**Addendum #1**  
**June 10, 2024**

**Westbrook Armory MOV/POV Compound Project, Westbrook, Maine - Project No. 23SR19-428-D**  
**Bid Number #24-047**

Directorate of Facilities Engineering

### ELECTRICAL SITE PLAN

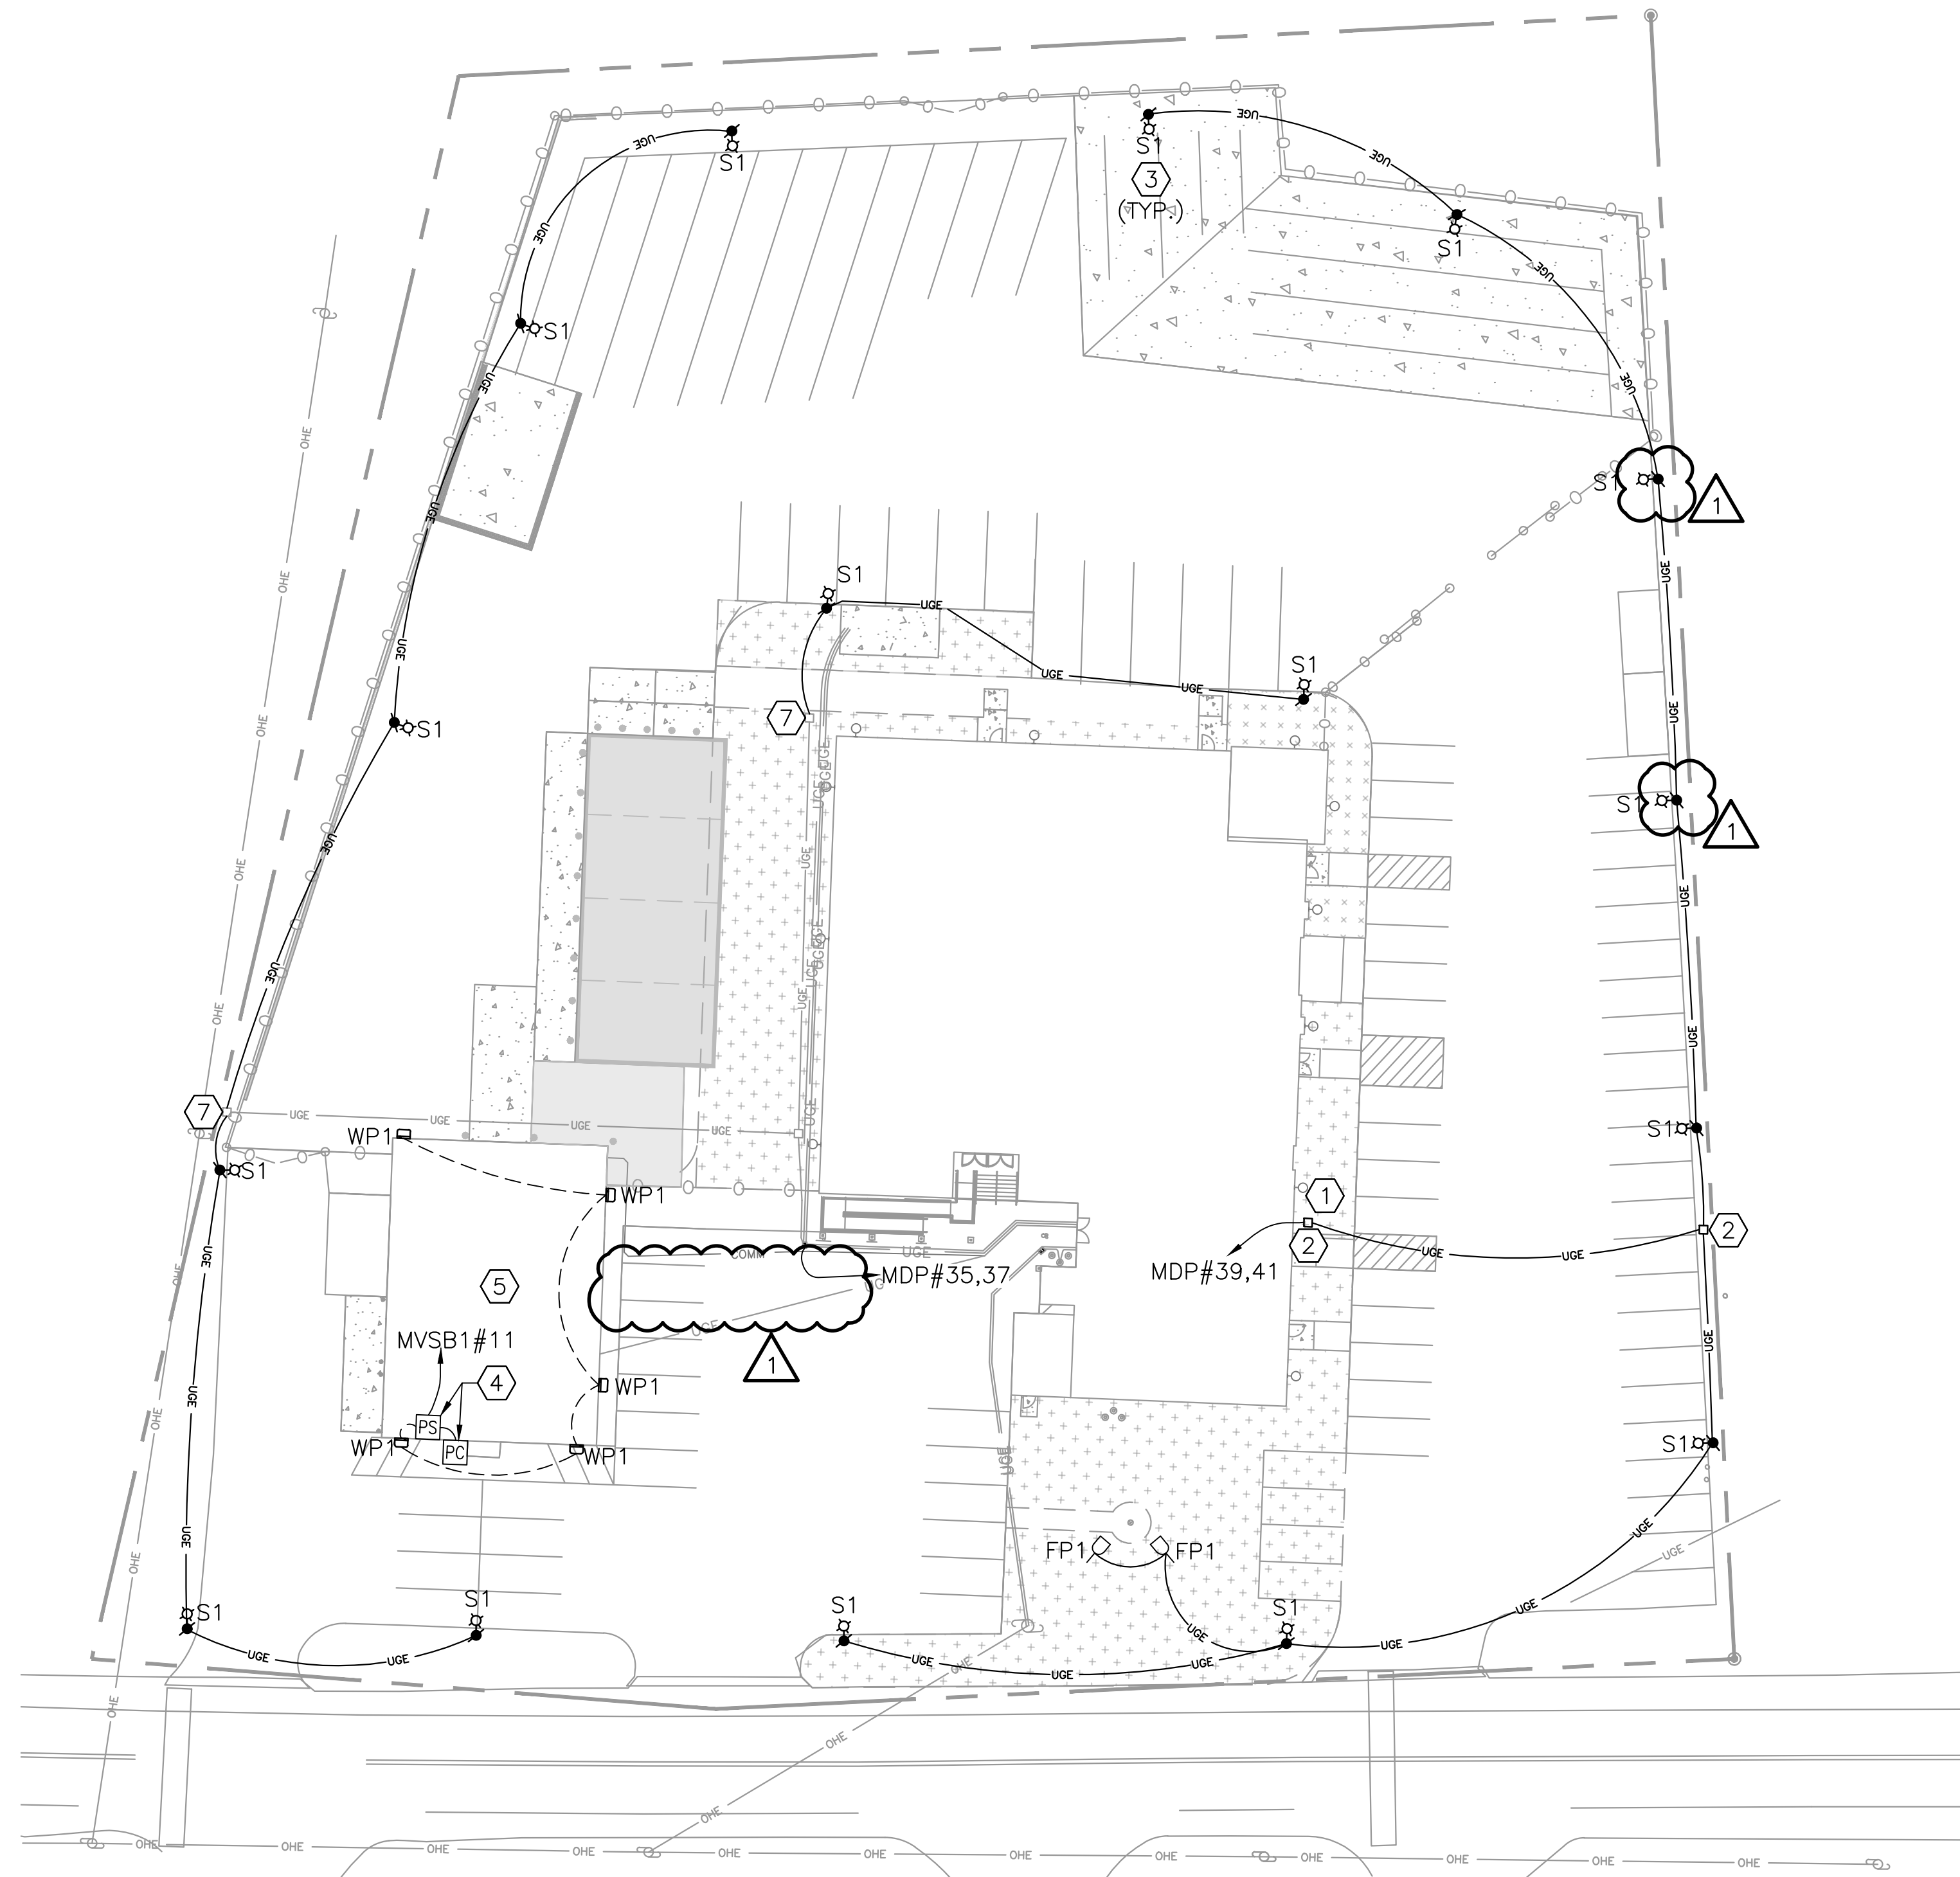
- g. C-503 - Removed the section with footing detail portion from the Typical Bollard Detail.
- f. ES-101 - Eliminates EV charging station and shows an adjusted location for light poles.
